3488A-19

S E R V I C E N O T E

3488A Switch Control Mainframe

3488A Upgrade Instructions (Installing updated 3488A Control Board that supports 44470D and 44471D modules)

Figure 3. Replace the Controller Board

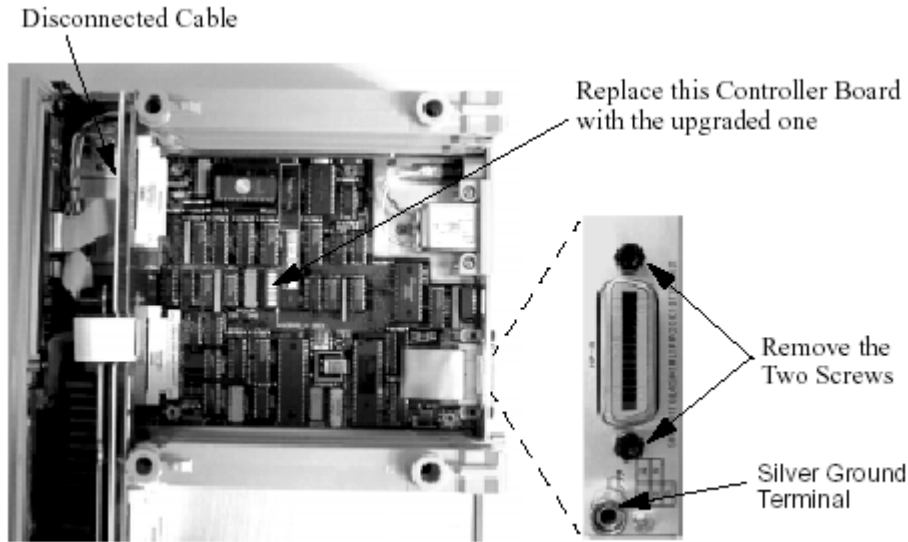
To replace the old Controller Board with the provided new one (03488-66541), you need to:

- Remove the posi-drive screw located on the rear panel below the silver ground terminal.
- Gently pull the Controller Board up and toward the rear of the unit to disconnect the Controller Board from the backplane board. The GPIB connector and rear panel will be removed with the Controller Board assembly. Lift the Controller assembly up and out.
- To install the provided new Controller Board, reverse the procedure.

Figure 4. Agilent 3488A Identifications

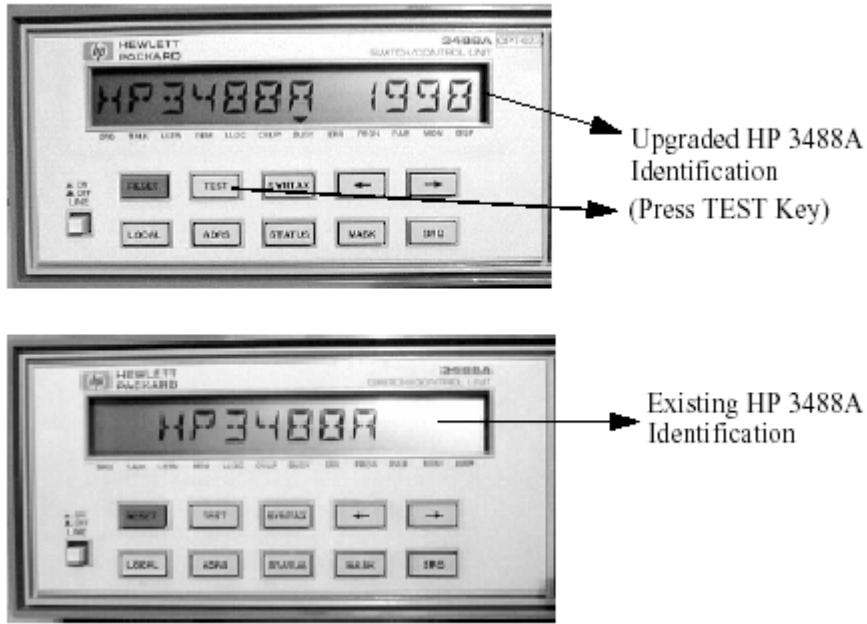
- Make certain that the provided new Controller Board, the shield, the front panel, the top cover, etc. have been installed into the Agilent 3488A properly.
- Connect the power cable and power up the Agilent 3488A, press the TEST key just below the display window. The display “**3488A 1998**” identifies that this Agilent 3488A mainframe has been upgraded successfully (the existing 3488A just displays “3488A”).

See Figure 4. for Agilent 3488A Identifications.

Upgraded Control Board will now allow use of all 3488A modules, including 44470D and 44471D.
